Business Unit: Electronics **PCN/17/017/PM+MD-US**
Product range: Circular Connectors Date: 2017-08-31
Title: M12 PushPull and Slim Design – Grip Improvement Page 1/3

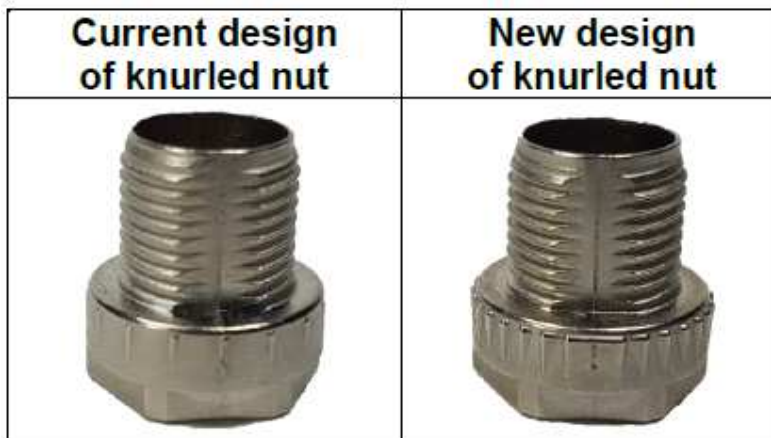
Improved grip characteristics of the union nut of M12 PushPull and M12 Slim Design connectors.

Improved grip characteristics of the knurled screw for male M12 Slim Design connectors.
